**From:** pbb338koser@aol.com  
**Sent:** Monday, July 31, 2017 4:36 PM  
**To:** Bauer, Patrick B  
**Subject:** Re: Supplemental Zoning Commissioner Questions

**From:** <[pbb338koser@aol.com](mailto:pbb338koser@aol.com)>  
**Date:** Monday, July 24, 2017 at 4:24 PM  
**To:** <[gstiltner@stiltnelectric.com](mailto:gstiltner@stiltnelectric.com)>, <[jimglasgow@q.com](mailto:jimglasgow@q.com)>, <[jhoughton@iclawnet.net](mailto:jhoughton@iclawnet.net)>  
**Cc:** <[uhclerk@yahoo.com](mailto:uhclerk@yahoo.com)>, <[zoning@university-heights.org](mailto:zoning@university-heights.org)>, <[ballard@lefflaw.com](mailto:ballard@lefflaw.com)>, <[jbilskemper@shive-hattery.com](mailto:jbilskemper@shive-hattery.com)>, <[louisebob@mchsi.com](mailto:louisebob@mchsi.com)>  
**Subject:** Supplemental Zoning Commissioner Questions

Below are a couple of supplemental questions from me and another three from Larry Wilson. Questions from the other zoning commissioners were solicited but as of this afternoon have not been received.

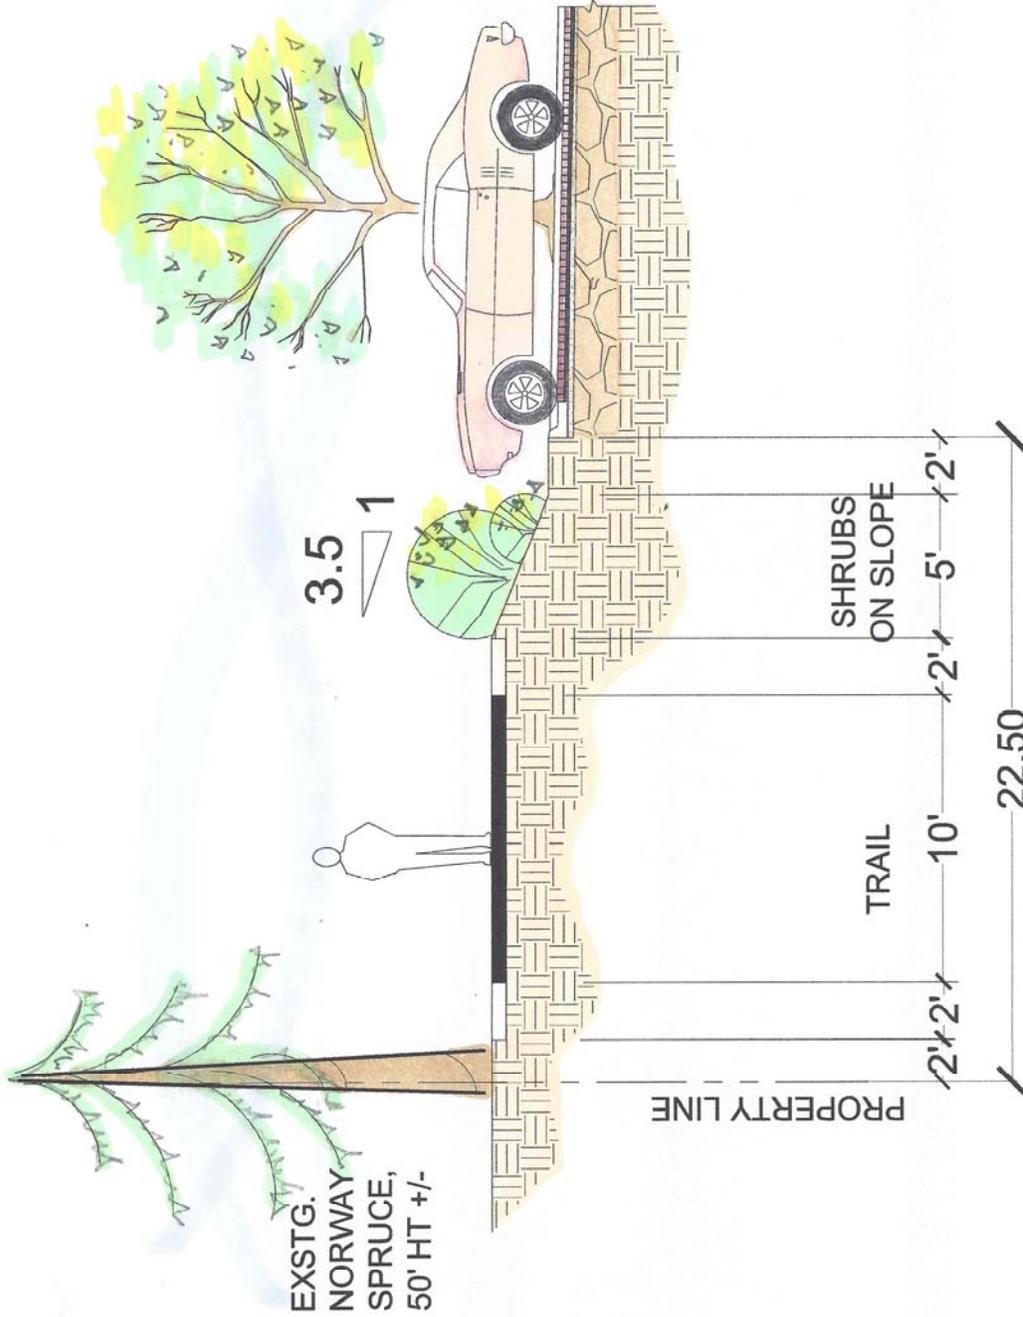
There seems to be little room to buffer the existing single-family homes to the west which are about 150ft from the hotel to the back door of residence on Olive Ct. and closer to the ones along the east side of the gravel drive (Melrose Ct). There apparently will be about a 10-12ft planting strip left on the east side of the proposed bike trail for the existing row of trees along the bike path (total of about 22ft minus the 10ft bike path. This is very little space to try to save existing mature trees, especially when the their roots to the east will be covered by parking, raising air & water for roots and construction damage concerns and place their survival in jeopardy. In addition, if the tree row is infilled with new trees, even sizable ones, it will be several years before they add much to buffer a 5-story building. This buffering will not be sufficient given the proximity, height and mass of the hotel and needs significant improvement. The following is an update to the response I sent below and in regard to the "Adequacy of West Buffer" Question:

Please see the attached for three options addressing possible west buffer solutions. Further descriptions of the options are as follows:

Structural soil is proposed for under the permeable pavement to provide air, soil and moisture to tree and plant roots. Structural soil is basically a stone on stone load bearing system with soil in void spaces. Structural soil mixes are two-part systems consisting of stone for strength and soil for horticultural requirements of trees and shrubs. Structural soils depend on a load-bearing stone system to support the pavement. The lattice of the stone provides a stone to stone contacts while allowing interconnected voids for root penetration, air and water movement.
